Telkwa Tenas Coal Mine, Canada

FROM: Dr Gilles Wendling, P.Eng.
TO: **What Matters in Our Valley**
DATE: May 28, 2022
SUBJECT: **PROPOSED TELKWA TENAS COAL MINE, BC, CANADA**

This is a memo completed on behalf of Environmental Law Alliance Worldwide (ELAW) for What Matters in Our Valley outlining comments and concerns of part of the BC EAO EAC Application – Tenas Project, for the proposed coal mine near Telkwa, BC, Canada.

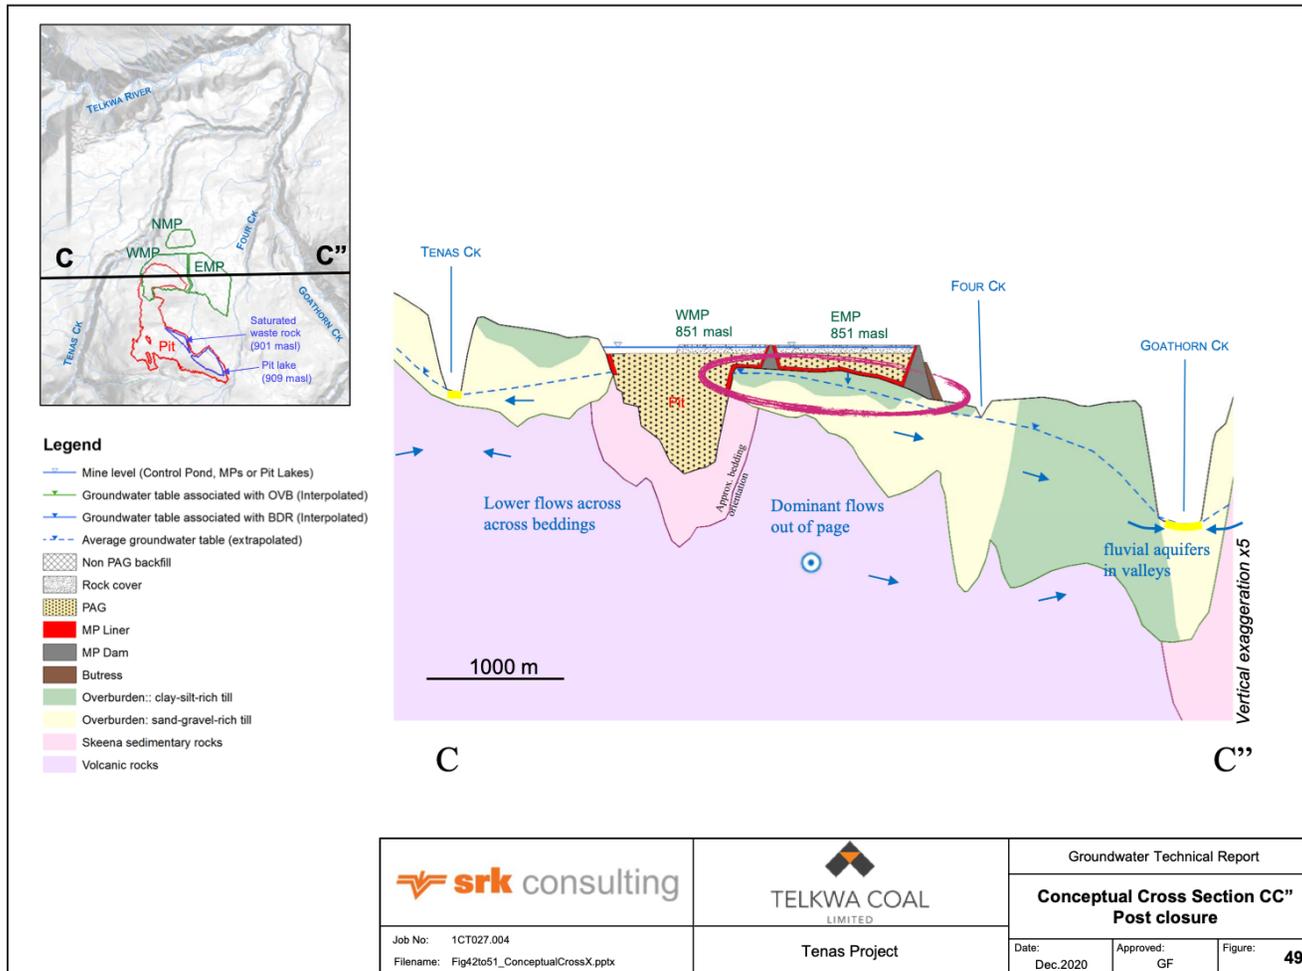
- Seepage is expected under the lined ponds (Figure 1). As the seepage will originate from PAG containing ponds, what will be the risk of poor-quality seepage affecting the quality of the groundwater discharging to the receiving streams (Four Creek and Tenas Creek in particular)? It is anticipated that the sealing capacity of the ponds will deteriorate over time, thus generating more seepage. What is the anticipated long-term effect of this process on water quality? It is understood that the ponds will be there permanently, so what can be expected 100 years or 200 years in terms of degradation of the water quality? Should the modeling underestimate the worsening of the groundwater quality, what would be the long-term solutions that could be proposed to address this impact to receiving water? What would be the cost of implementation of such solutions? Has it been considered in security bonds? Which organization would be responsible for such long-term (decades, centuries?) intervention and mitigations? What are the guaranties that Telkwa Coal Ltd.'s directors would still be involved and liable?
